Bulletin No. 2003-07

## Incorrect Handle On Pontoon Models

### Models Affected

FW71HP

**a** - Clicker used on extending handle only

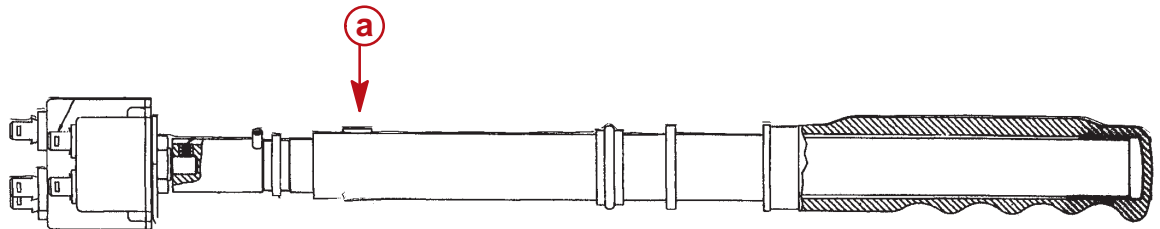
Manufacturing may have installed the incorrect non extending handles on the above listed pontoon model motors.

If a non extending handle is found on the above listed models within the listed serial number range, replace the handle with **P/N MBT372092**. If there is no clicker on the handle, it is a non extending handle and should be replaced.

Qty. One (1) MBT372092 Handle assembly
